PROJECT: Consentino Middle
School RFI NO.: 14PR1

PROPOSED CHANGE ORDER**No. CMS-029R1****TITLE:** Change Hold Opens per Submittal**DATE:** 11/22/2024**PROJECT:** Dr. Albert B. Consentino Middle
School**JOB:** CSM-2024**TO:** City of Haverhill
685 Washington Street
Haverhill, MA**CONTRACT NO:****DESCRIPTION OF CHANGE**

PROPOSED CHANGE ORDER**No. CMS-042R1****TITLE: BFA Seq 30-34****DATE: 11/12/2024****PROJECT: Dr. Albert B. Consentino Middle School****JOB: CSM-2024****TO: City of Haverhill
685 Washington Street
Haverhill, MA****CONTRACT NO:****DESCRIPTION OF CHANGE**

RFI #114: CMS - RFI 114 - Norgate RFI - 058 Seq 30-34 Clarifications

31B8-B

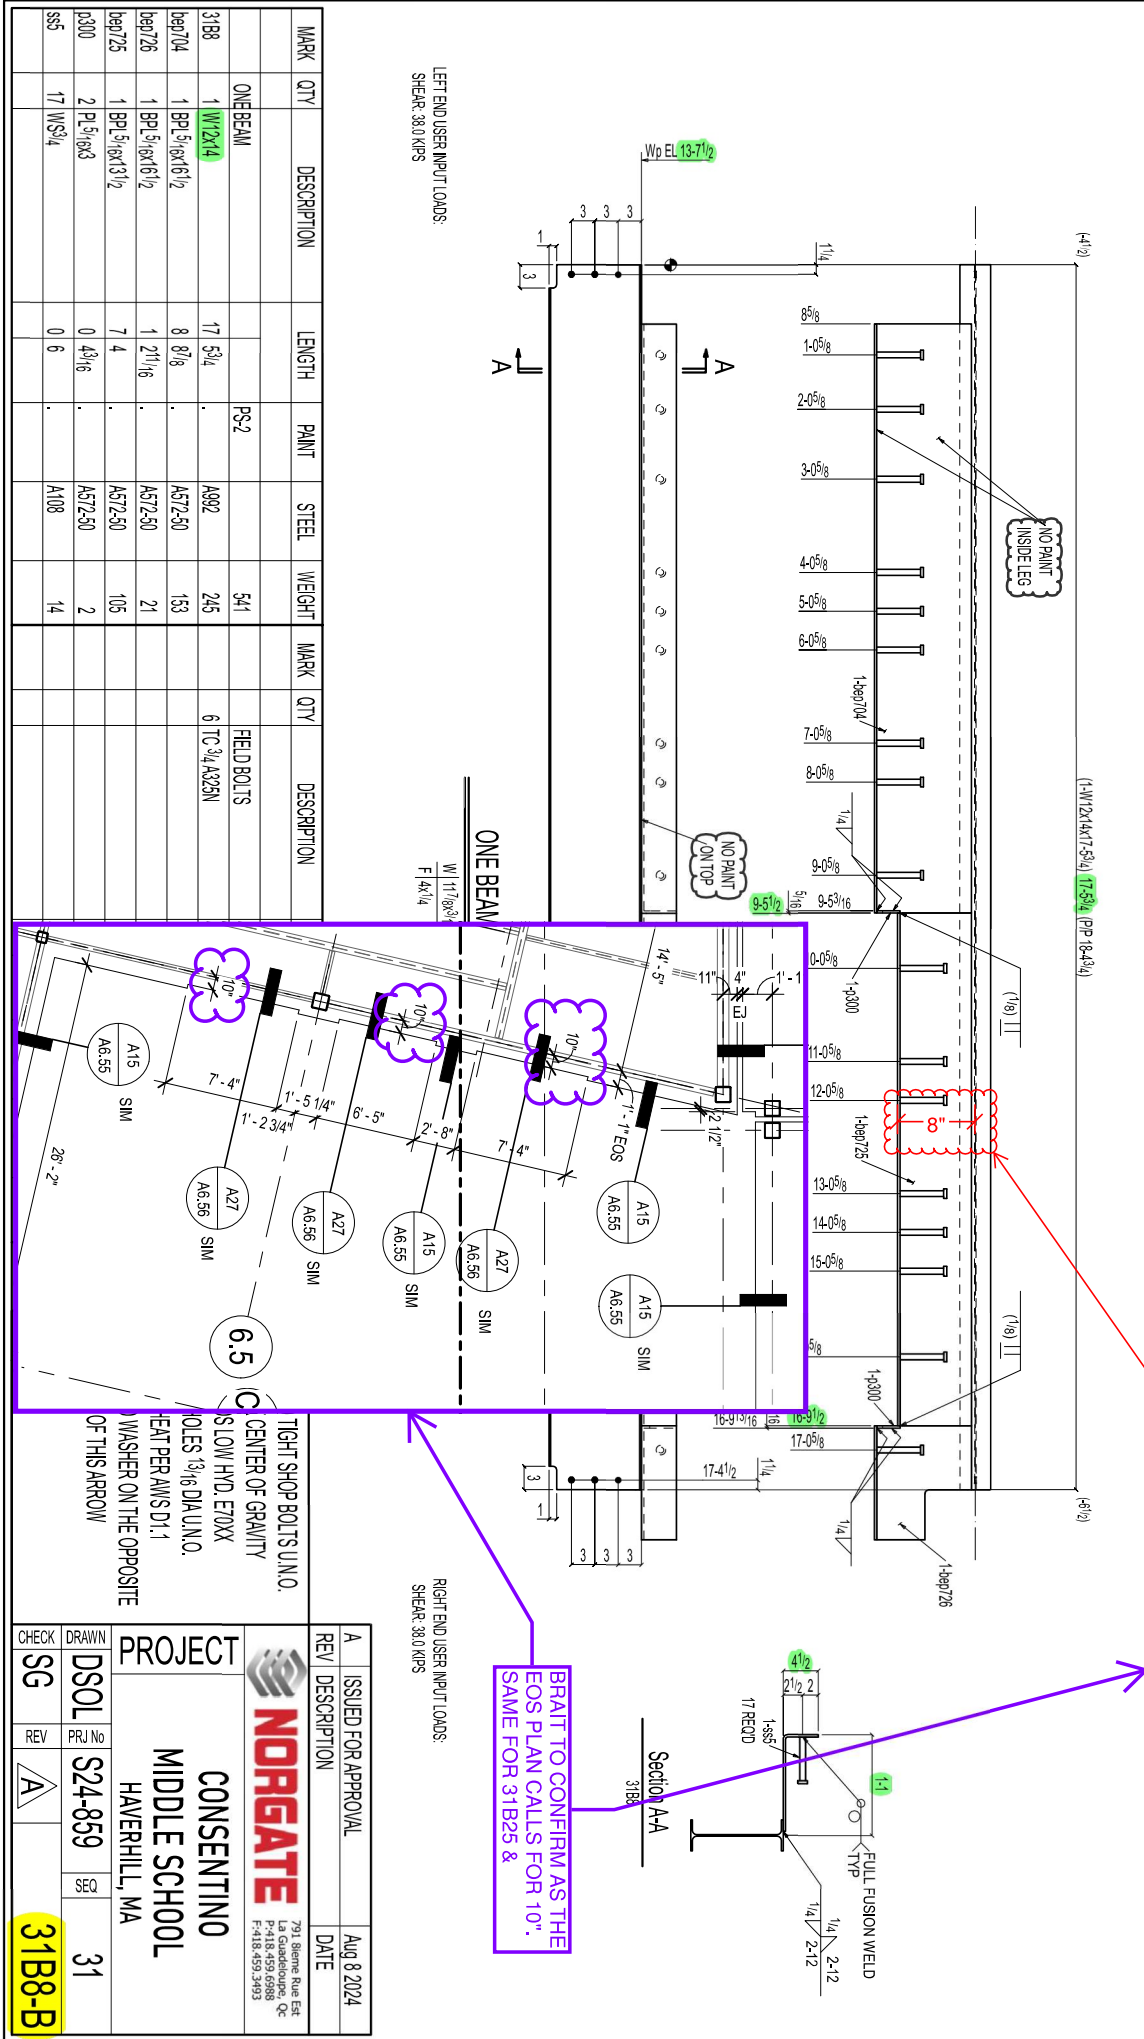
BRAIT TO CONFIRM AS THE
EOS PLAN CALLS FOR 10".

Slab edge to be coordinated with 084413-002
Curtain Wall Shop drawing submittal. Submittal
Indicates 8" from grid line to slab edge. GC to
confirm.

31B26-C

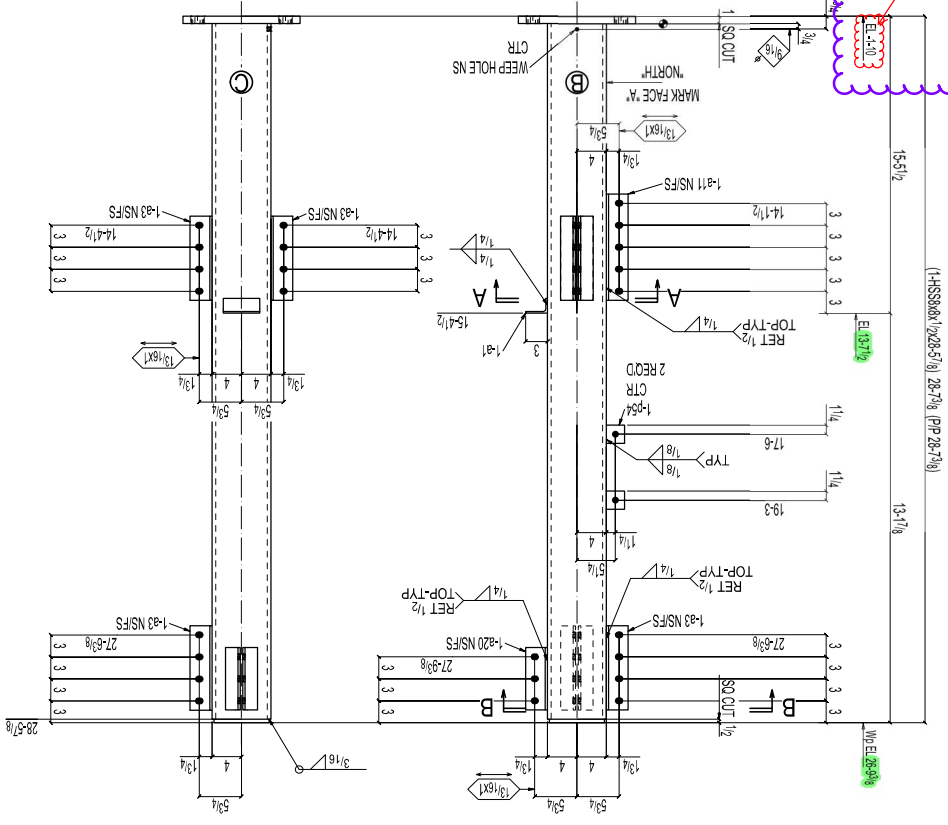
EDG: Elevation -1.1' ±.
G/C to confirm
elevation of pier in
the field.

BRAIT TO CONFIRM

3 BEAMS 33B36
W 18x38
F 70, 28k

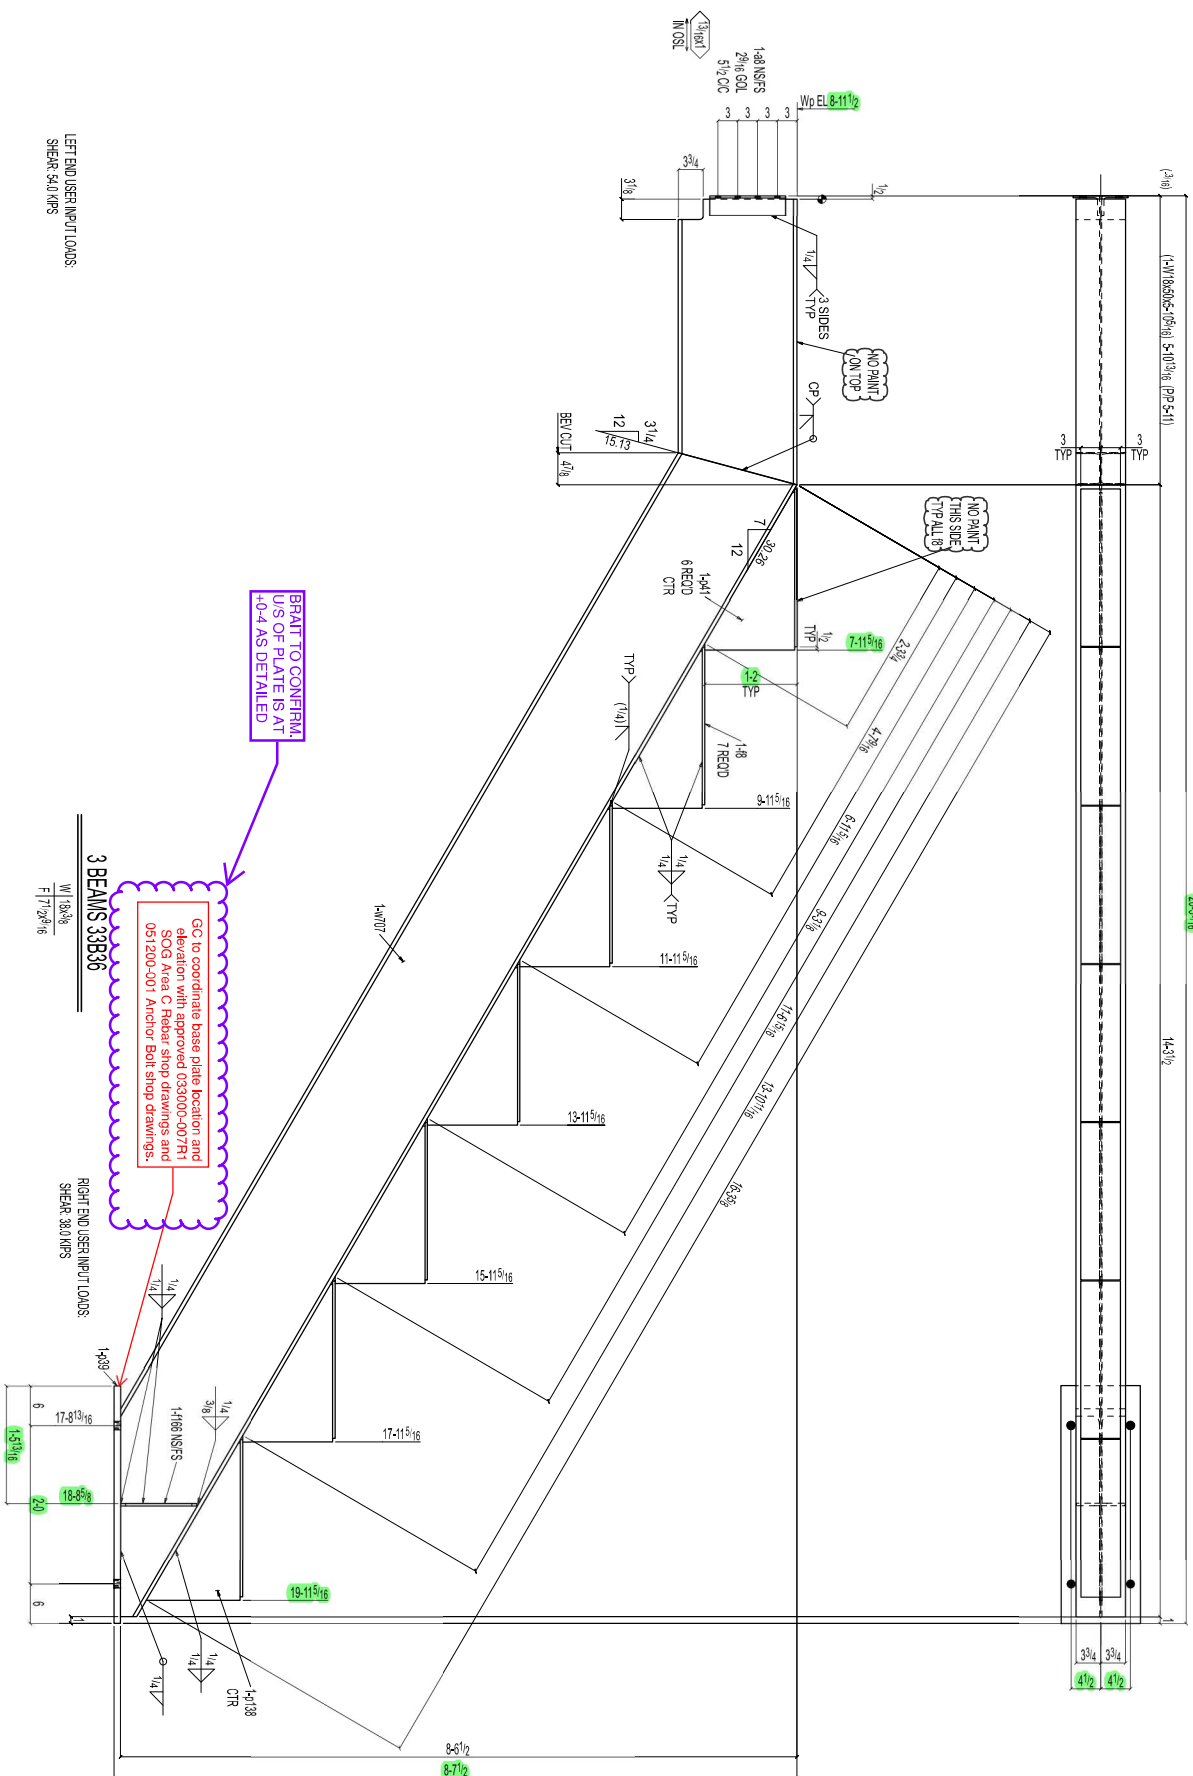
GC to coordinate base plate location and elevation with approved 033000-007R1 SOG Area C Rebar shop drawings and 051200-001 Anchor Bolt shop drawings.

BRAT TO CONFIRM, US OF PLATE IS AT +0.4 AS DETAILED

E133

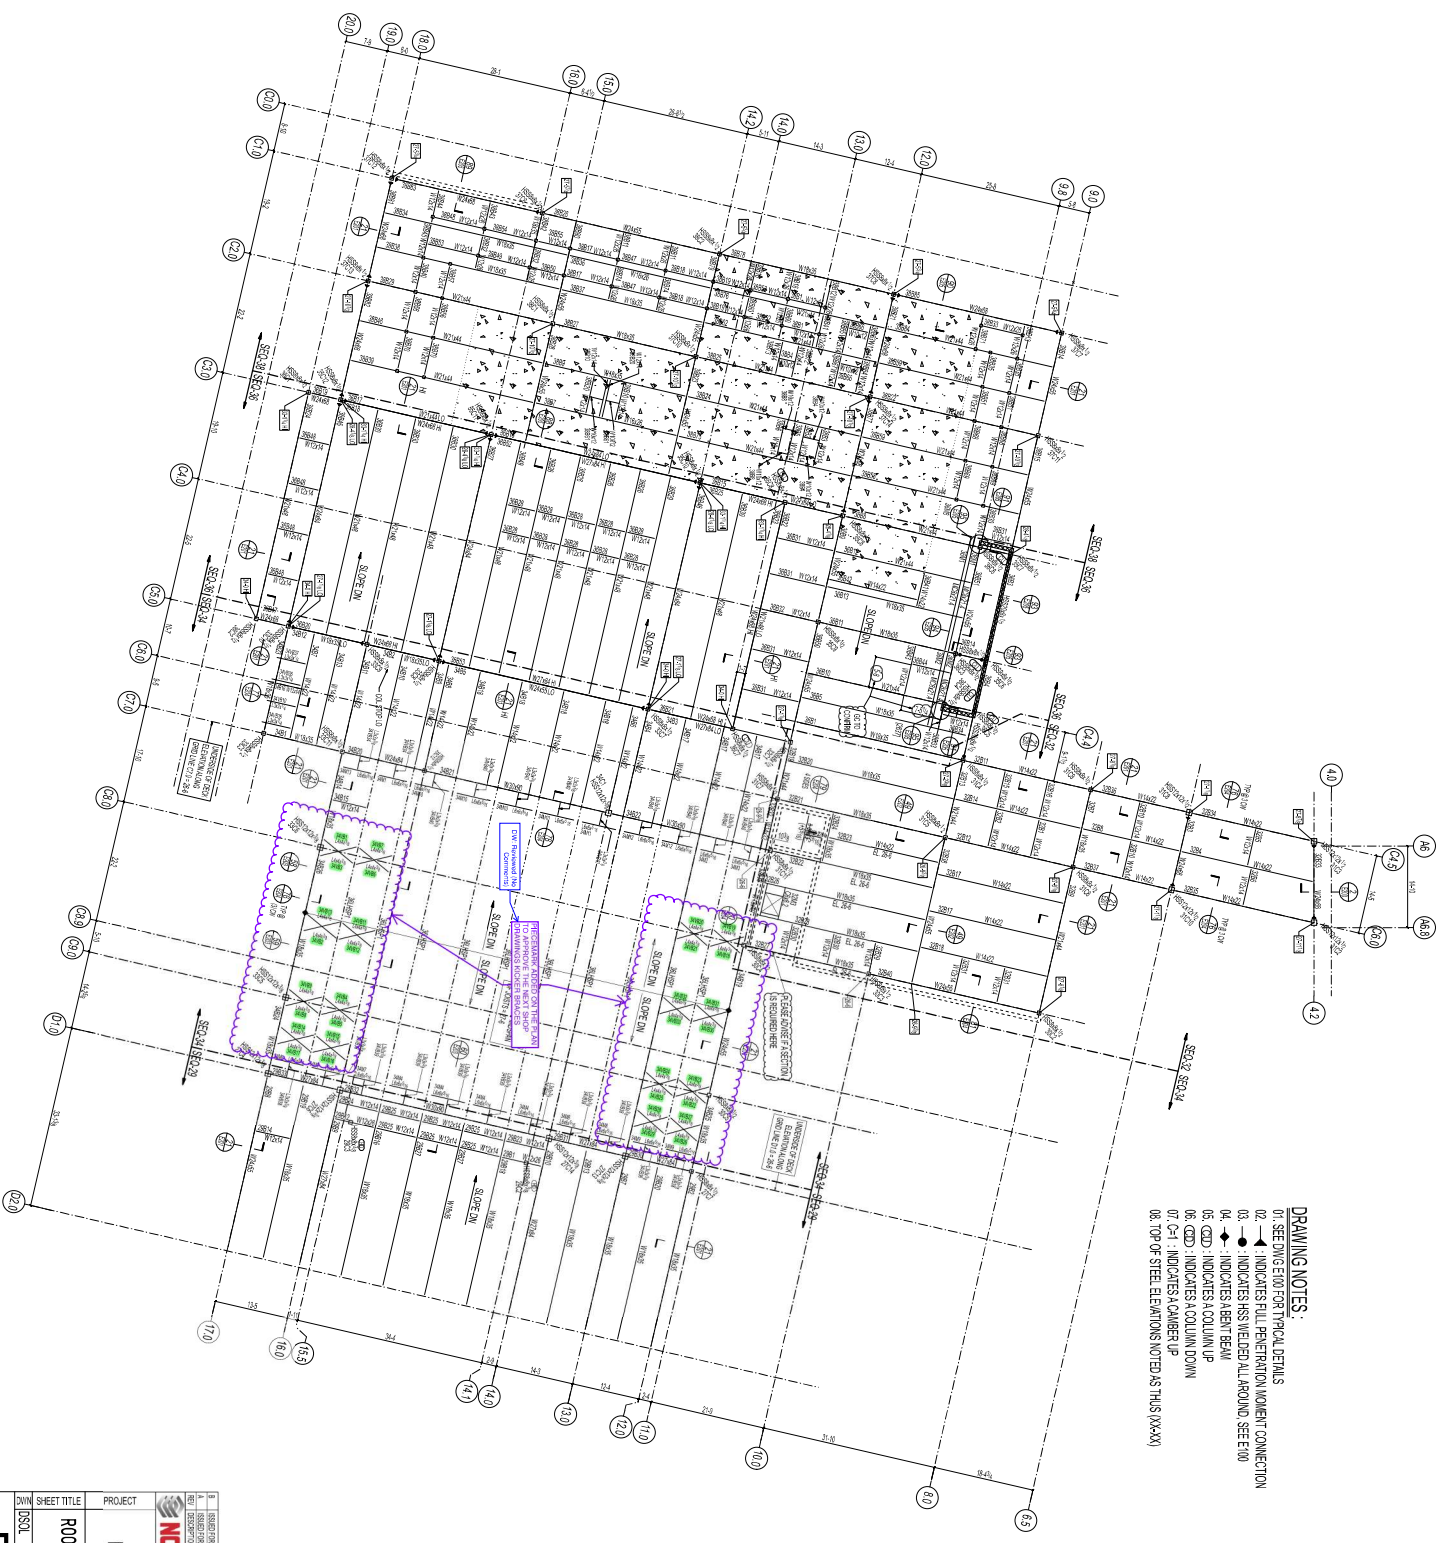
Architect please confirm elevation of steel on page 6.

Brace pieces are structurally acceptable.
